Tarheel Lodging Redevelopment

Certificate of Appropriateness Phase-II Modifications

August 23, 2022

14UPDATED 8-30-22; 2nd Submittal Revised 11-8-22

**OAS-4 Design Intent/Programming: Outdoor
Amenity Space - 4 is intended to provide seating for
quiet conversation and reading. Songbird houses
and plantings designed to attract birds and
butterflies are proposed.**

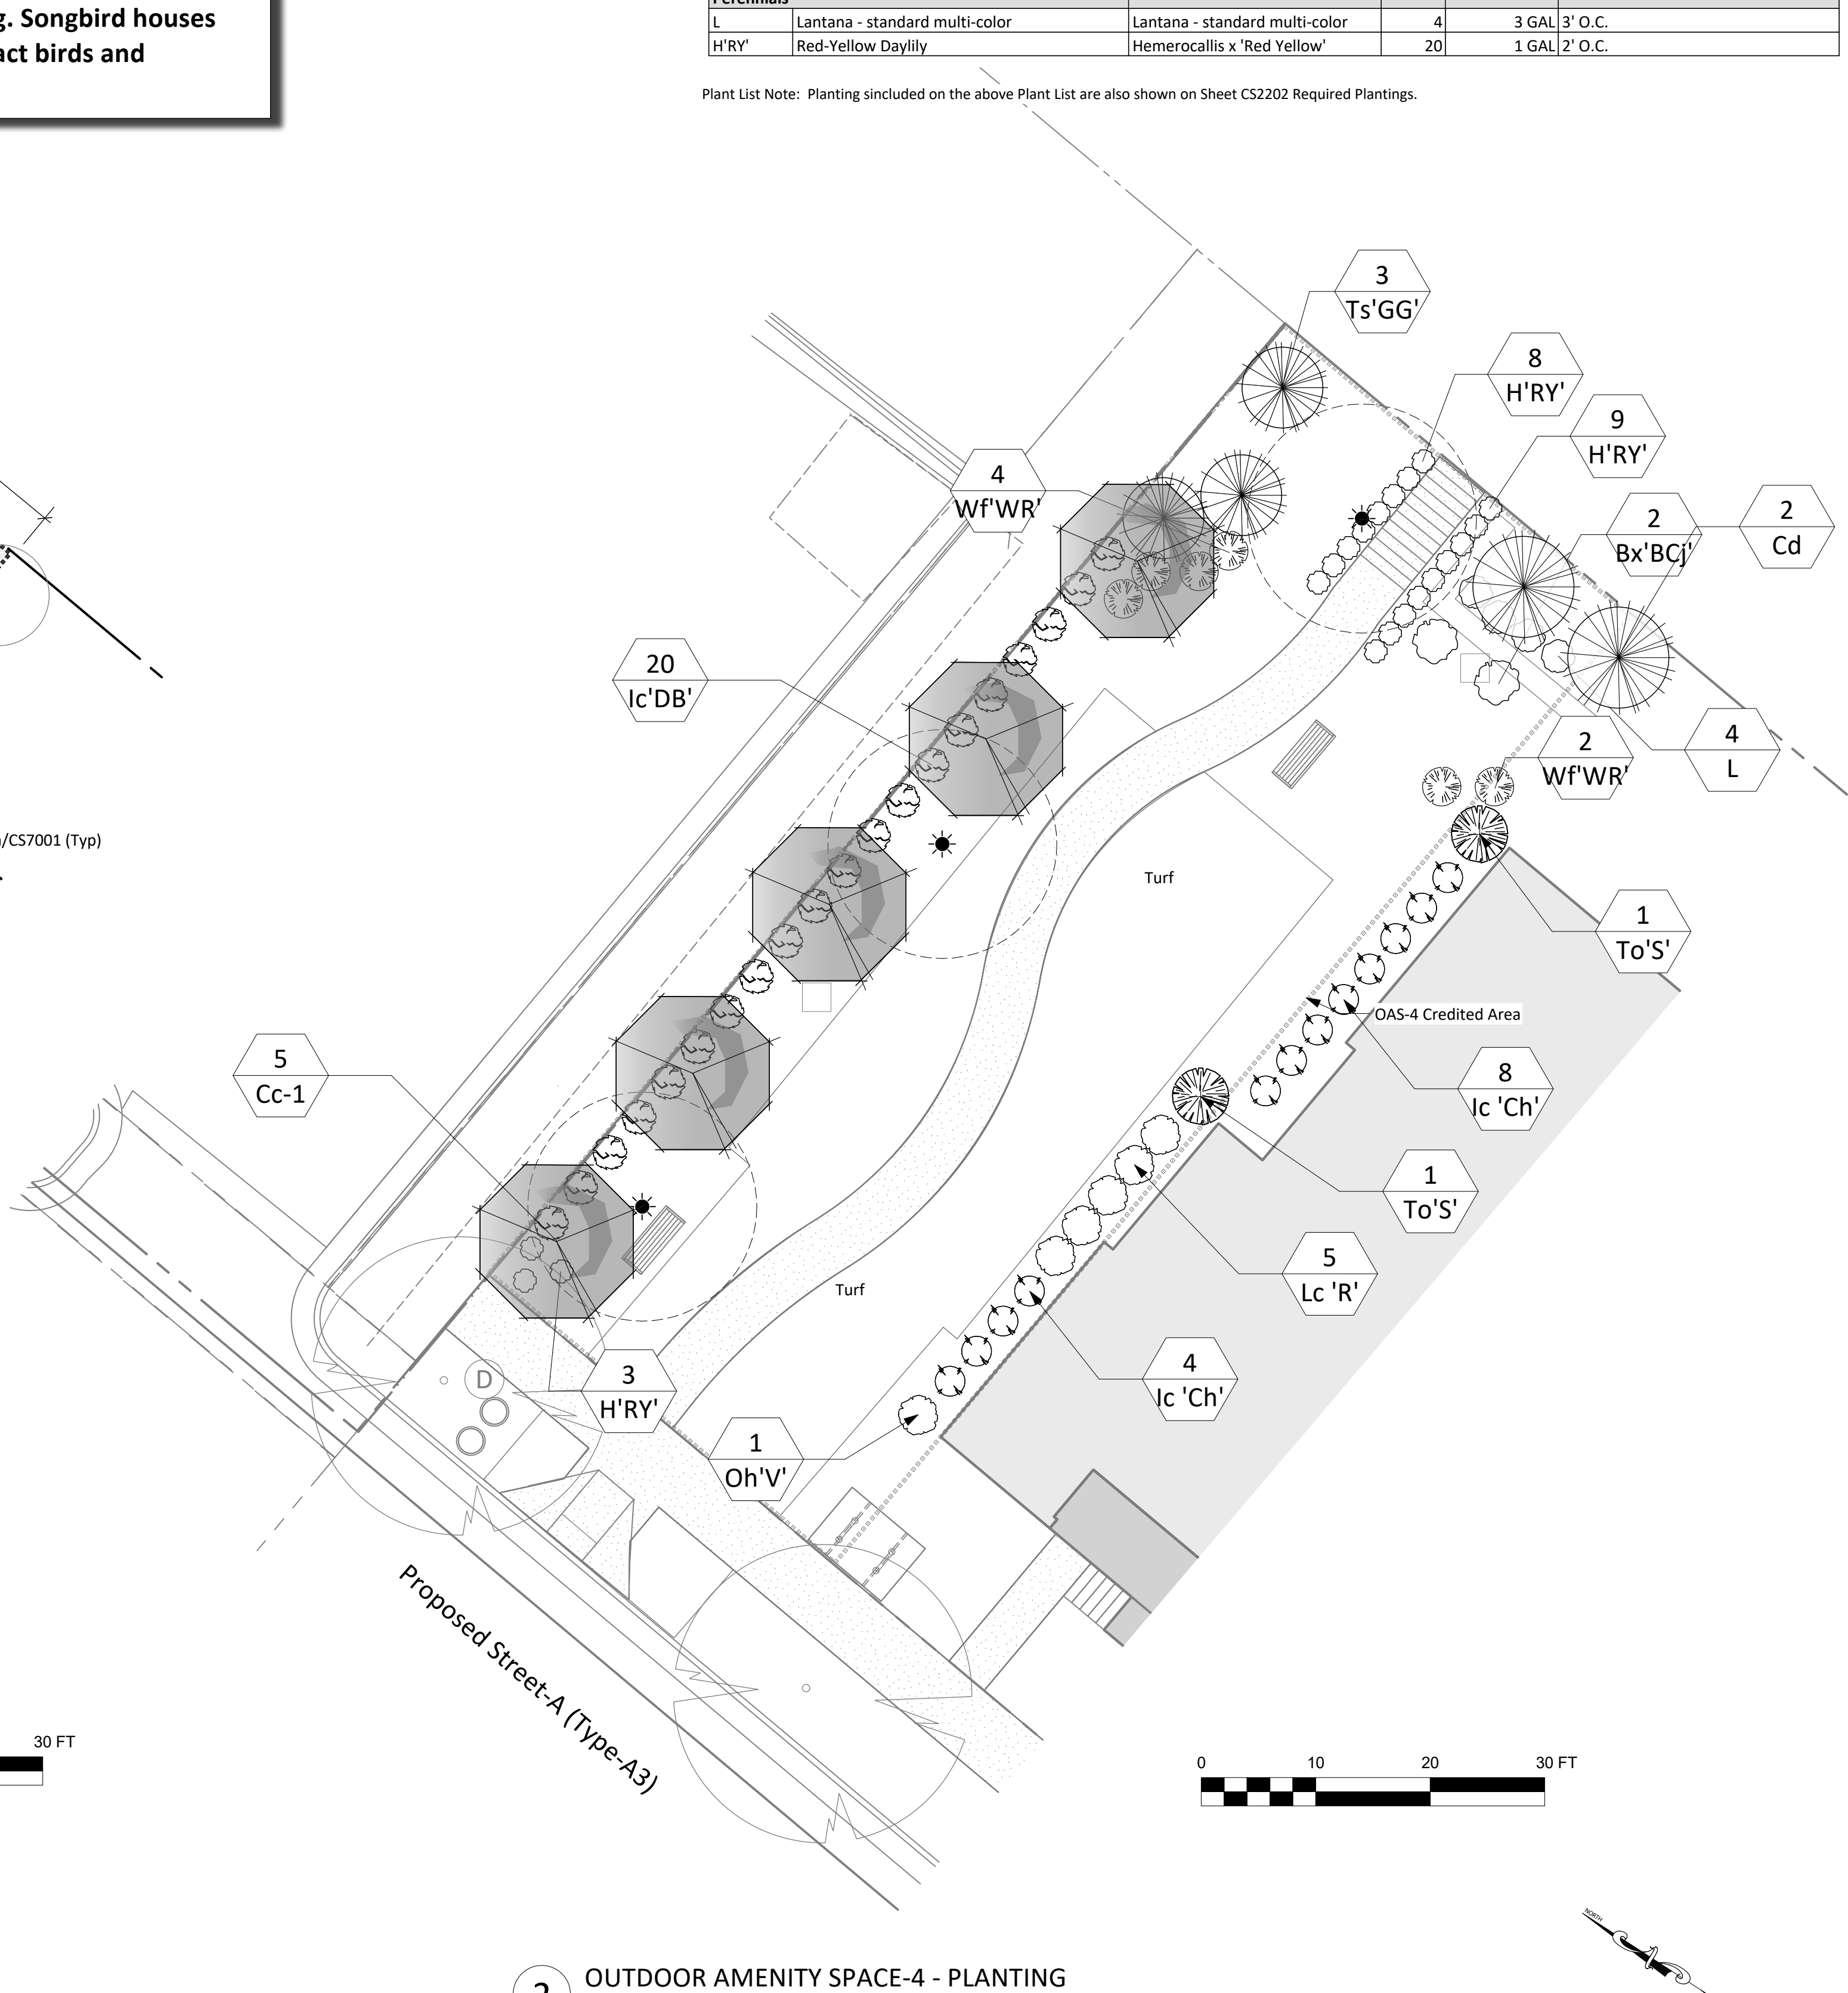
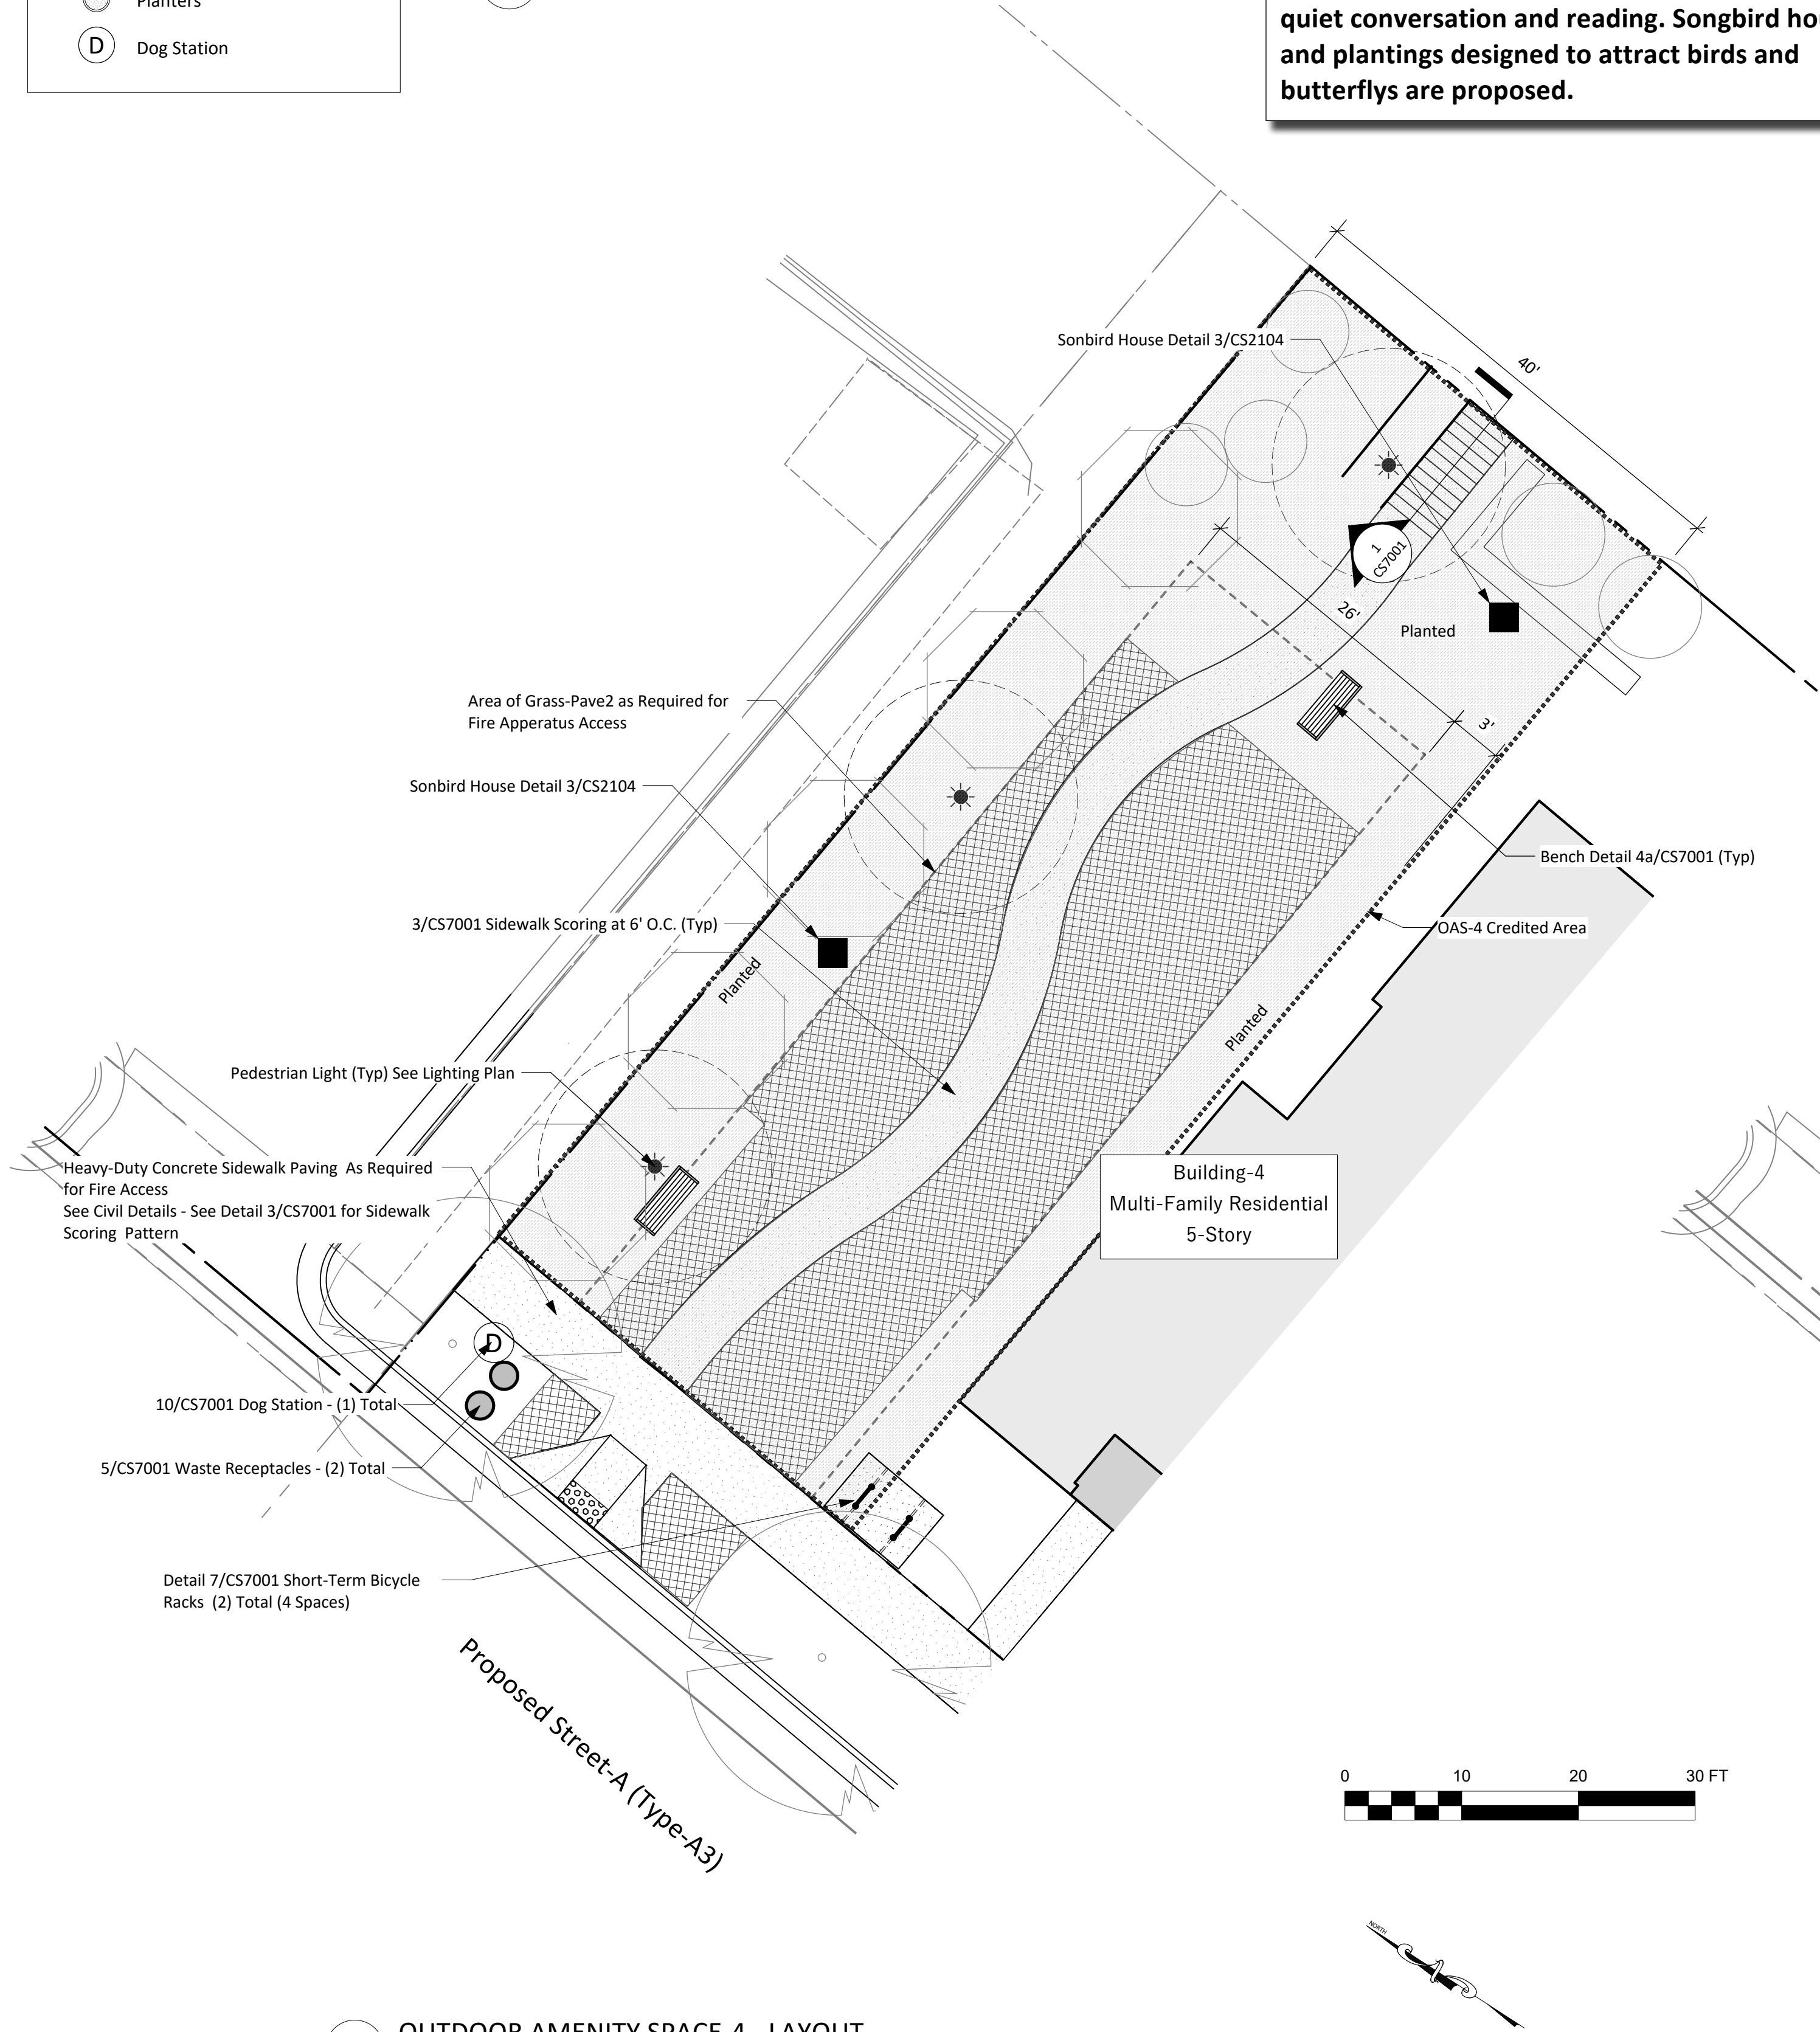
2	10-14-22	Revise OAS-4 width
1	8-30-22	Phase-II Modifications
No.	Date:	Issue Notes:
